VALUE ENGINEERING STUDY

Project # CSSTP-0006-00(252) PI No. 0006252
Project # CSSTP-0006-00(253) PI No. 0006253

**S.R. 44 from US 441 to I-20
Putnam/Greene County, Georgia**

6 December 2012

PROPOSAL NUMBER: R3-8

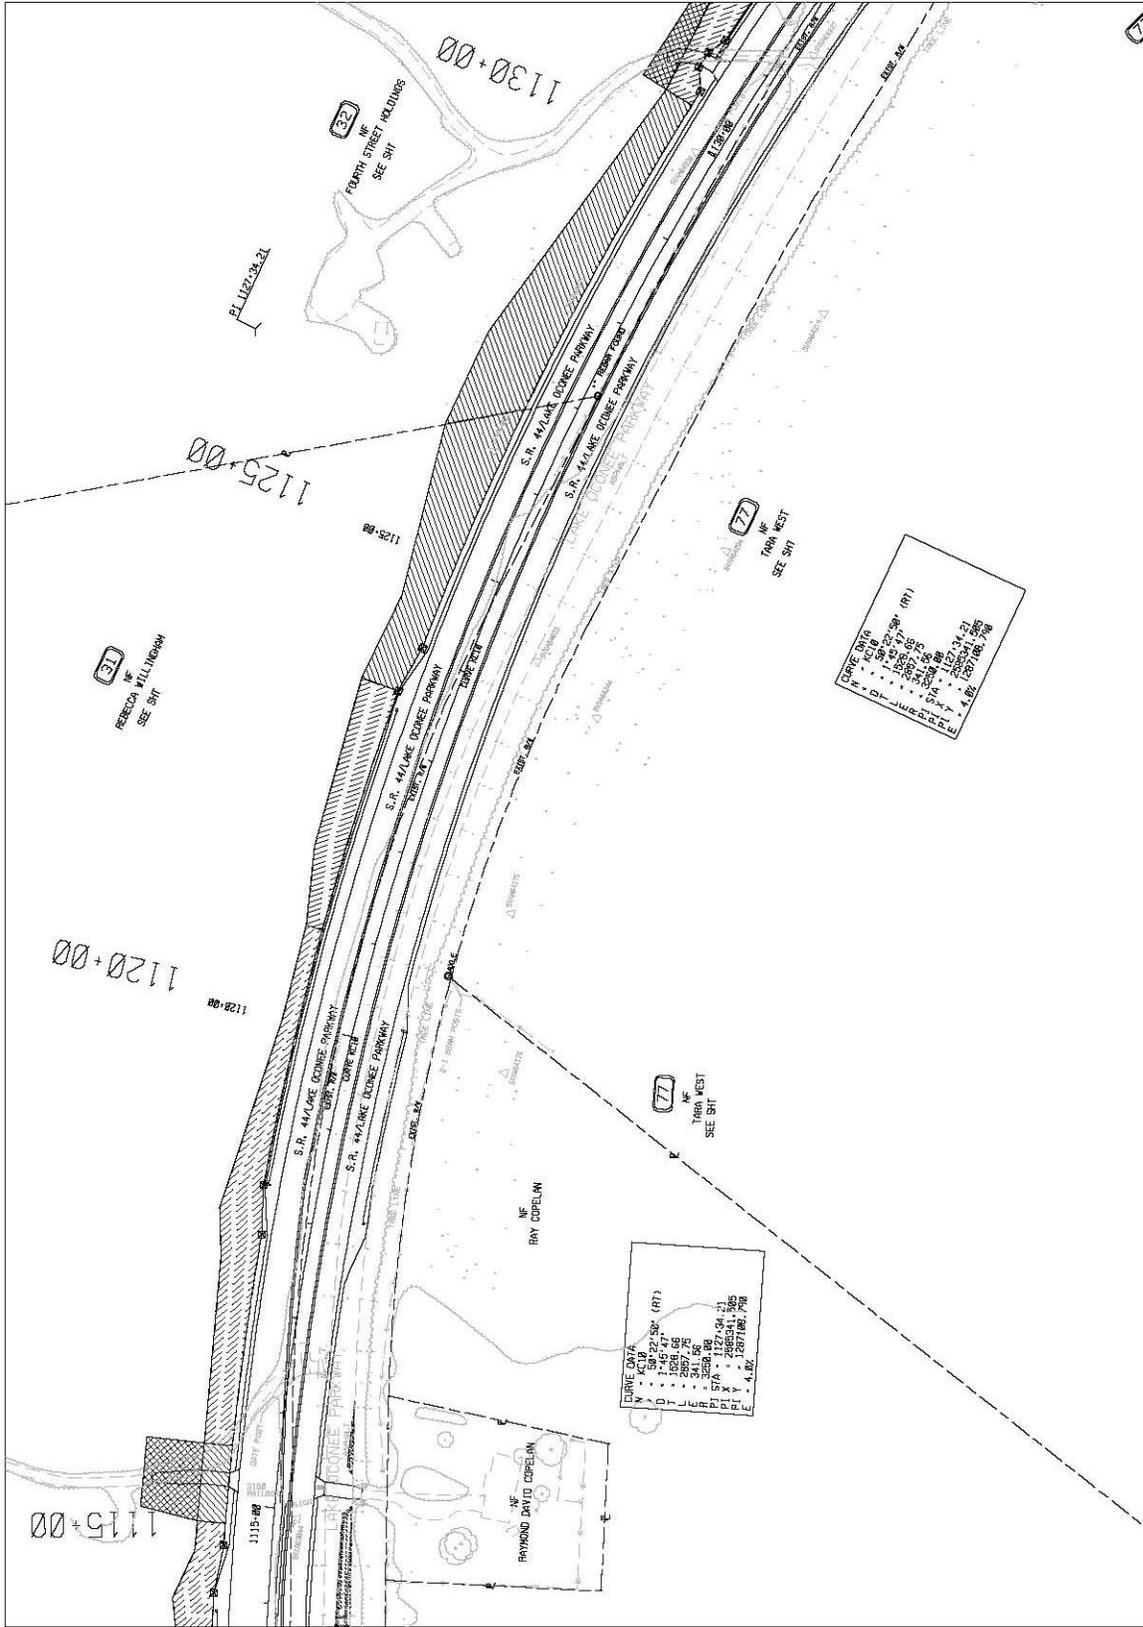
PROPOSED CHANGE: It is proposed to shift the horizontal alignment of SR44 to more closely follow the existing curved alignment and avoid impact to the lake located at Sta 1093+00 and avoid taking the house on Parcel 34 at Sta 1135+00.

JUSTIFICATION: The alignment of SR44 can be revised to closer match the existing and will meet the required 55 mph speed design in the rural section and will meet the requirements of GDOT and AASHTO.

R3-9 Original Design
3 of 5

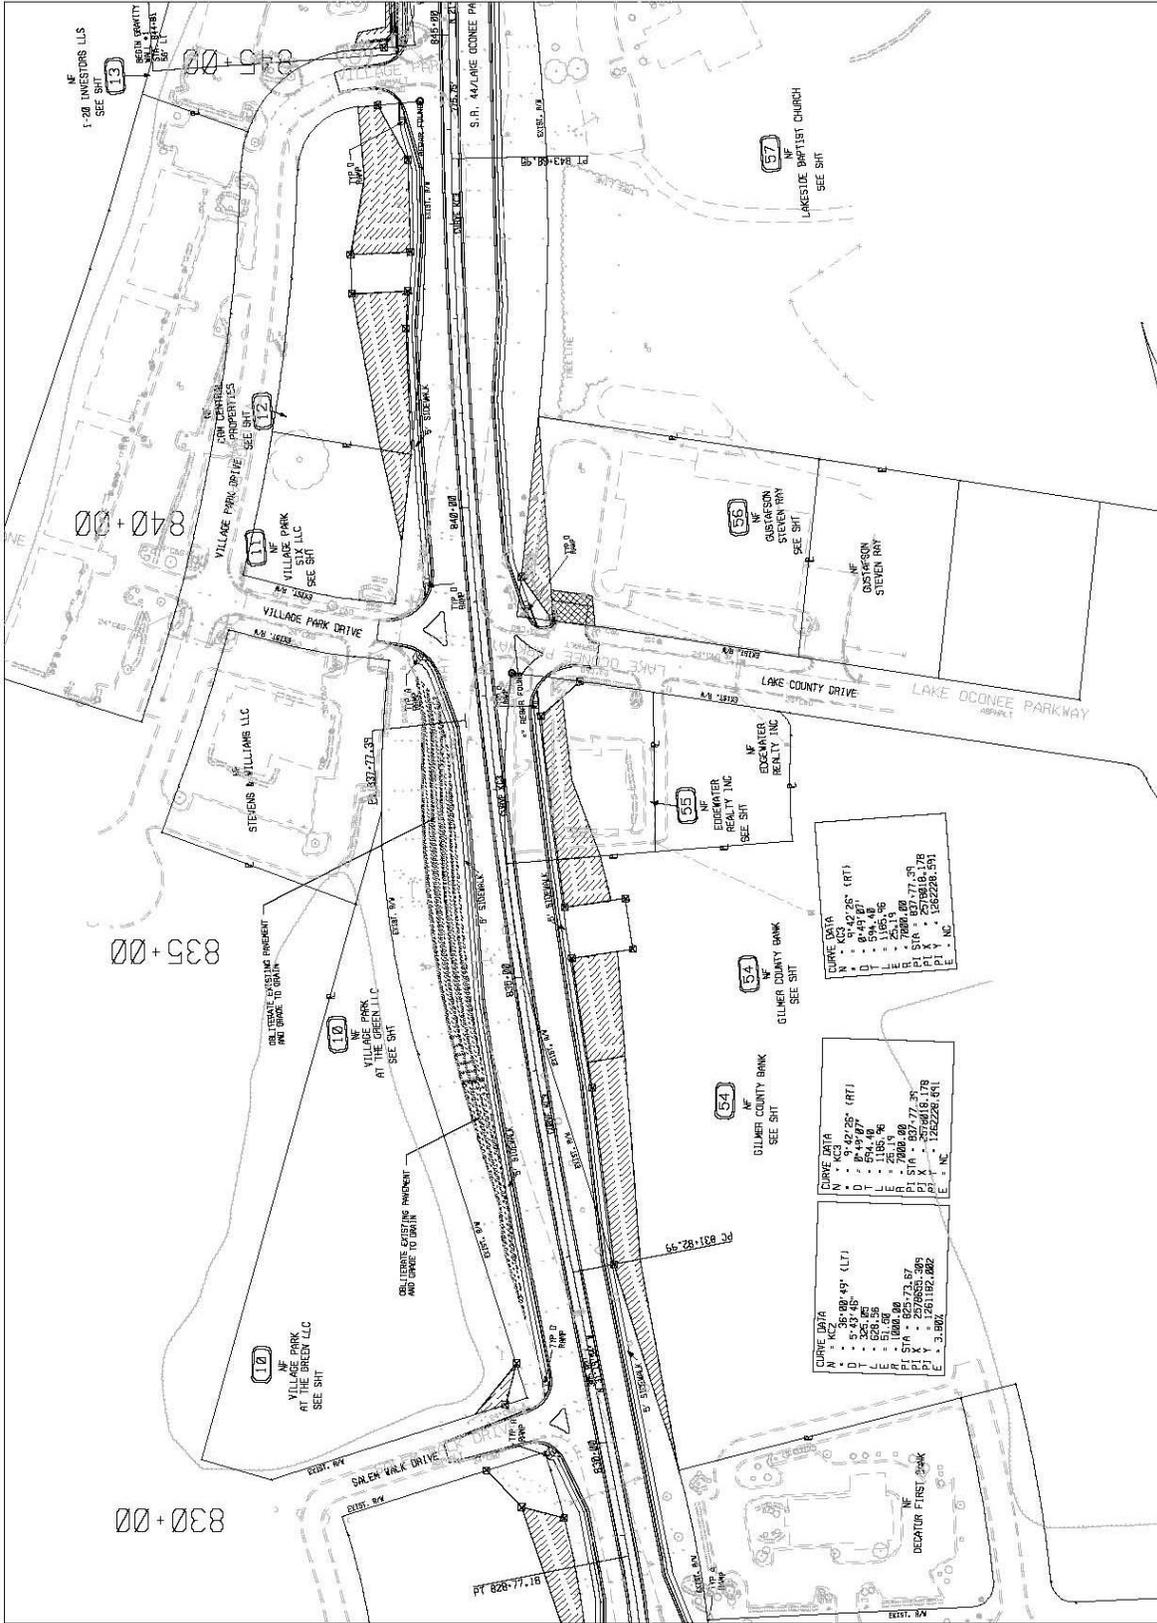
PROPOSED CHANGE: It is proposed to shift the horizontal alignment of SR44 to more closely follow the existing alignment and avoid the displacement of Parcel 55.

JUSTIFICATION: The alignment of SR44 can be revised to closer match the existing and will meet the required 45mph speed design in the urban section and will meet the requirements of GDOT and AASHTO.
